**Assessment of Ten (10) Protected-Size Trees
At and Adjacent to
16666 Topping Way
Los Gatos, California**

Prepared for:
Sean Mullin, Associate Planner
Town of Los Gatos Community Development Department
110 E. Main Street
Los Gatos, CA 95030

Report by CTA
1/17/2020

1.0 **(b)** Summary of tree disposition and tree issues, based on the applicant's most current grading and drainage plan sheet C2 by SMP Engineers of Los Altos, dated 12/5/2019, and the current proposed landscape plan sheet L1 by Todd Kalbfeld Landscape Design of San Jose, dated December, 2019.

SCALE: 1"=10'

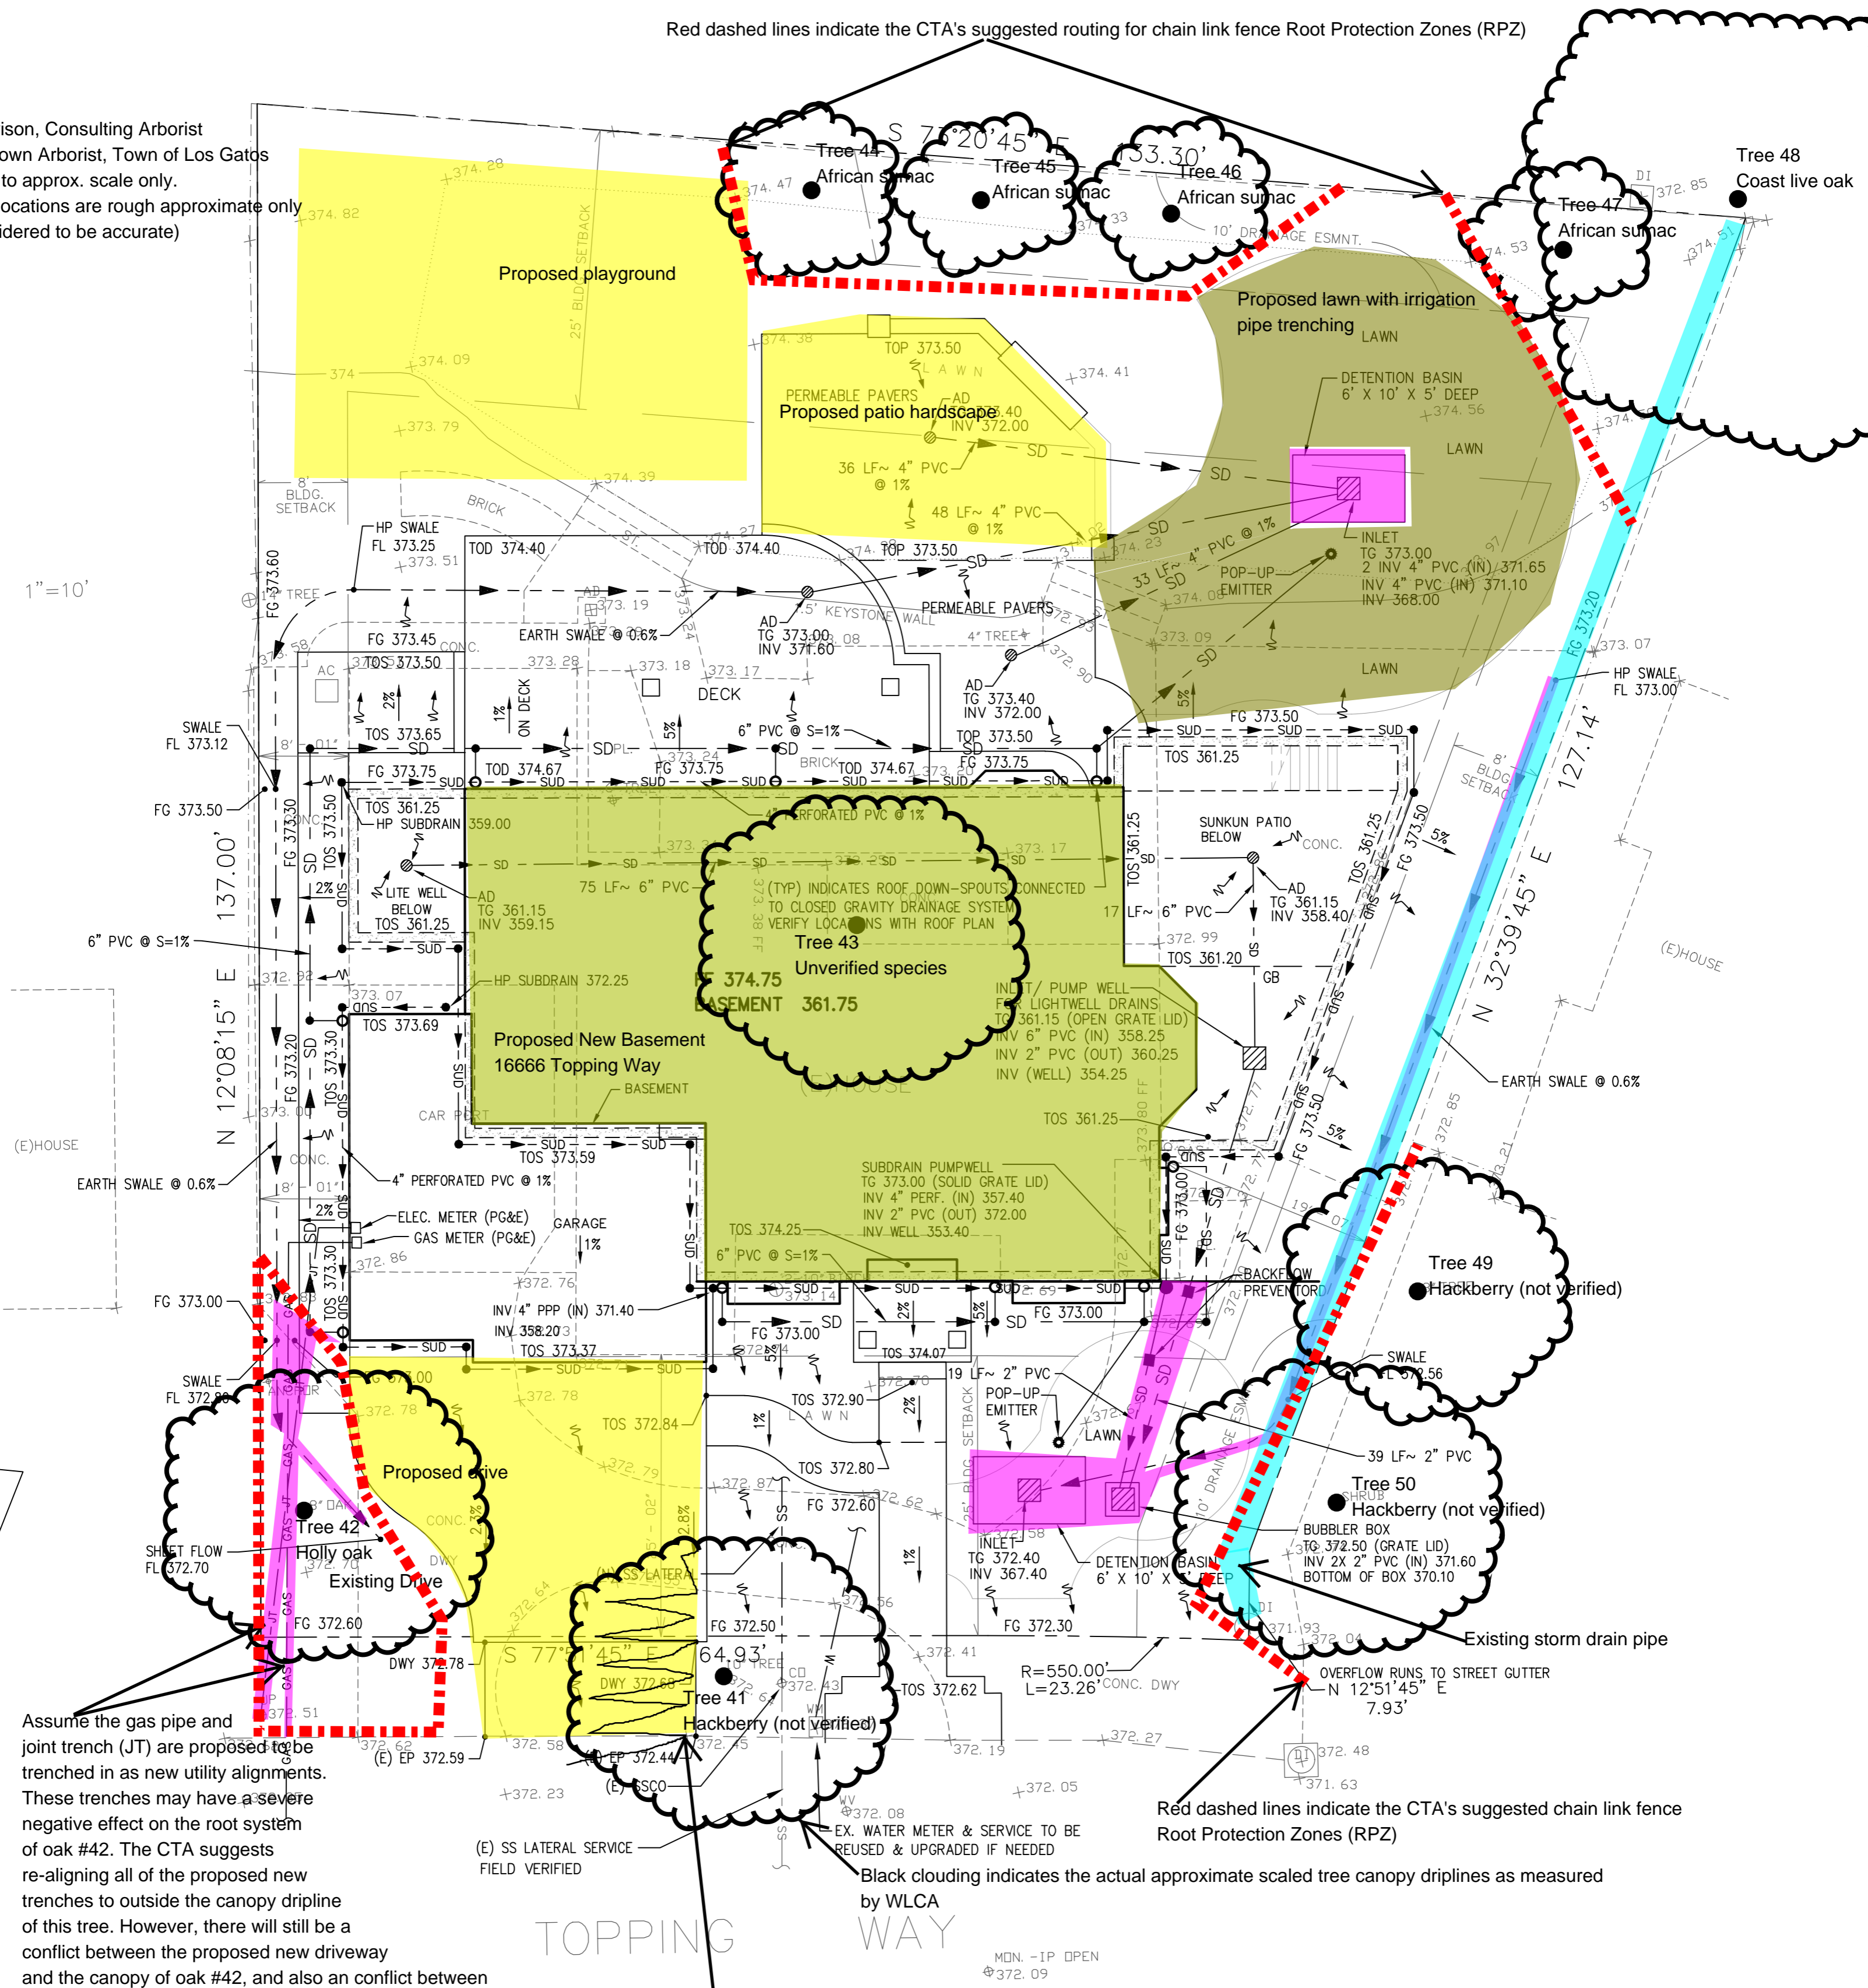
-Tree plot locations are rough approximate only (not considered to be accurate)

Assume the gas pipe and joint trench (JT) are proposed to be trenched in as new utility alignments. These trenches may have a severe negative effect on the root system of oak #42. The CTA suggests re-aligning all of the proposed new trenches to outside the canopy dripline of this tree. However, there will still be a conflict between the proposed new driveway and the canopy of oak #42, and also a conflict between the root system of oak #42 and the proposed new driveway, which can only be remedied by use of a geogrid underlayment placed directly over the soil surface prior to laying baserock, in order to create a "no dig" driveway that does not require any excavation into the subgrade.

Proposed new driveway footprint will conflict with tree #41 root system. This tree may need to be removed if the drive is to be built out as currently proposed by the applicant. The conflict area is shown as black line drawing. However, in reality, the root system of a tree extends much much farther than the canopy dripline (e.g. 50 feet radius, etc.)
